# WOLF CREEK

ET 00-0010

Subject: Docket No. 50-482: Supplemental Response to Generic Letter 96-06 (TAC NO. M96887)

**SUBJECT: Letter Report Assessment of GL96-06 Waterhammer Analysis Assumptions and Available Margin**

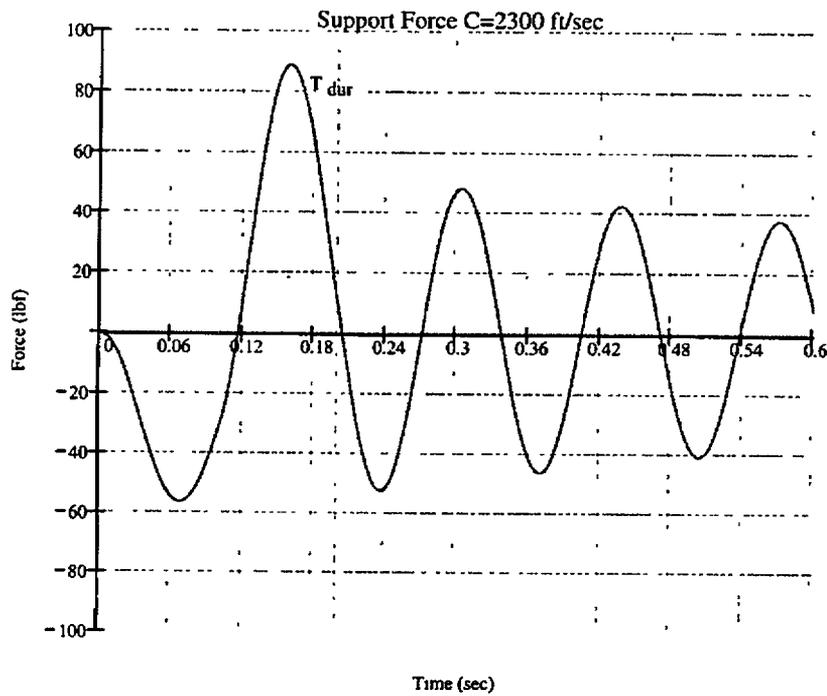
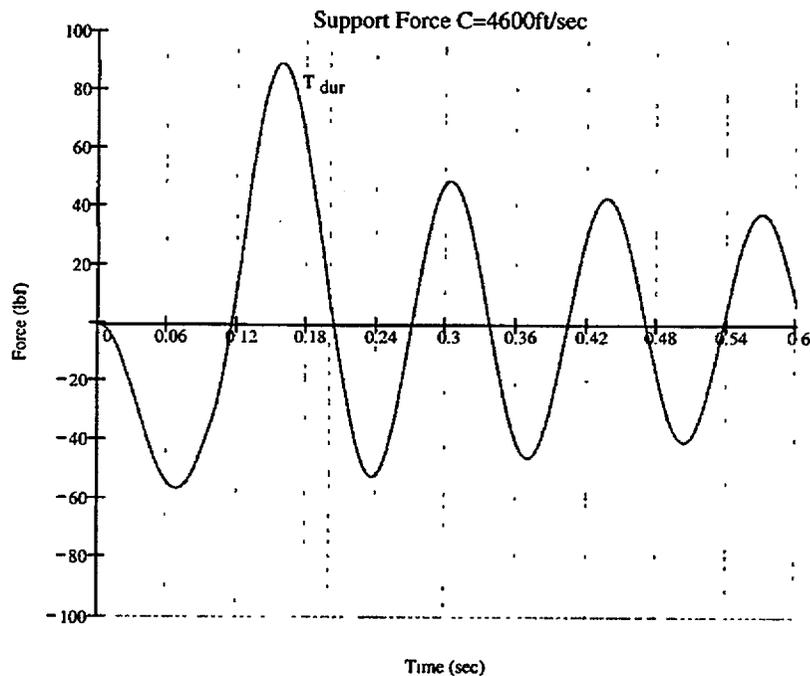
Repeat the problem using the increased sonic velocity (doubled from 2300 to 4600 ft/sec) which produces a doubled water hammer pressure pulse (225 to 450 psi). The solution will show that the support load is the same.

The following plot shows the resulting force on the pipe support (spring) resulting from the differential pressure across the pipe segment. The sonic velocity and pressure differential have been double but the Support Force is the same.

Doubling the sonic velocity does not change the support loads as can be seen below. A review of the force-time history plots shows that the duration and other characteristics are also equivalent.

$$F_{\max 2300} = 89.331$$

$$F_{\max 4600} = 89.368$$
